SUBMISSIONS REPORT

Mayfield Site Port-Related Activities Concept Plan

December 2010

Prepared for Newcastle Ports Corporation
Corner Scott and Newcomen Streets | Newcastle | New South Wales | 2300
www.newportcorp.com

Figure 3-1 $L_{Aeq, 15\text{minute}}$ Daytime Noise Levels for 2034 Site Operations – Neutral Conditions

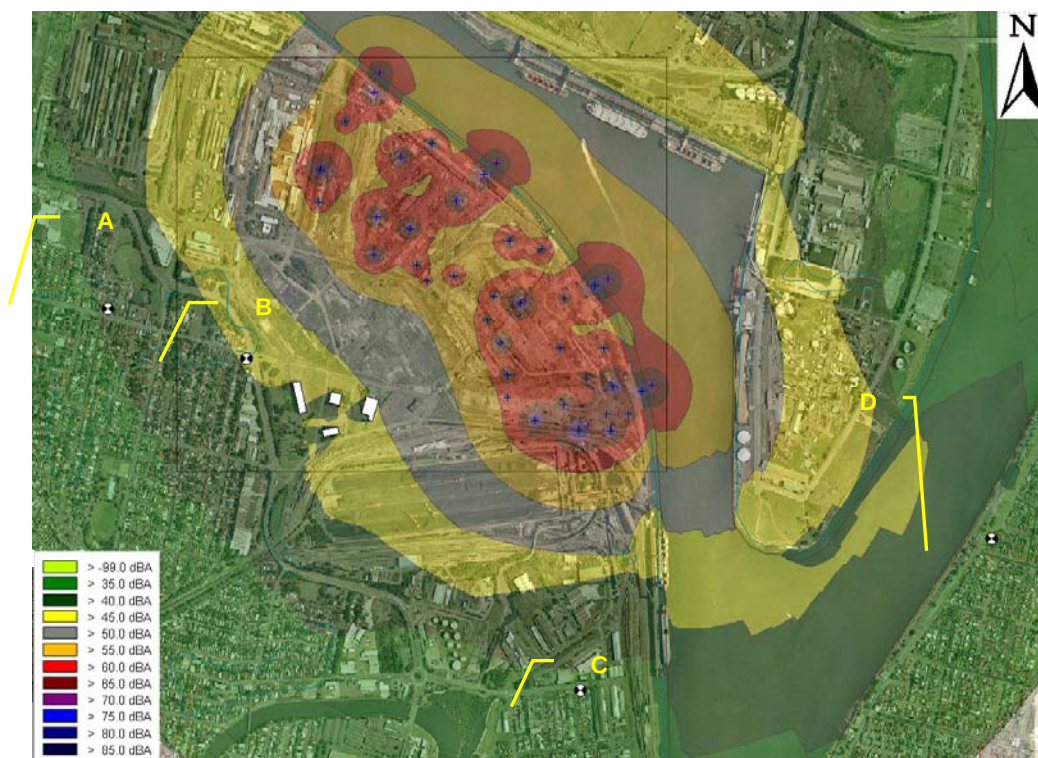
- b) The output figures from the "Cadna A" acoustic noise prediction software have been enhanced and provided as **Figures 3-1** and **Figure 3-2** of this Submissions Report. The modelled individual noise sources at the site are shown as blue crosses on the figures and marked A, B, C and D. The intervening structures shown to the south east of noise monitoring location B are the former BHP buildings, including the Administration building, that have been retained on the IIP site. The noise contours have been lightened to show the base layer more clearly.

- g) The output figures from the “Cadna A” acoustic noise prediction software have been enhanced and provided as **Figure 3-1** and **Figure 3-2** of this Submissions Report. The noise contours on the figures have been lightened to clearly show the base layer. As a result, the predicted noise levels from operation of the proposed concept in 2034 at residential areas surrounding the site are also shown more clearly.

It is important to note that **Figure 3-1** and **Figure 3-2** of this Submissions Report present the predicted noise levels from operation of the proposed concept without factoring in the use of noise mitigation measures. Based on the results of the noise modelling, it was recommended that noise mitigation measures be adopted by Project applicants for specific developments proposed at the site (refer to Section 9.3.4 of the EA). For example, it was recommended that the design of loading or unloading facilities at future developments should take into consideration Mayfield and Stockton residences in particular. Reductions in the order of 5 to 10 dBA can be readily achieved by strategically located noise barriers and buildings constructed in proximity of noise sources. Higher reduction in the order of 20 dBA can be achieved by constructing enclosures/buildings around noise sources requiring mitigation. Reductions of up to 10 dBA can be achieved by using acoustically treated motors and high performance silencers on equipment. Based on the findings of the noise assessment, the EA concluded that operational noise impacts associated with the proposed concept are manageable and can be mitigated to acceptable levels.
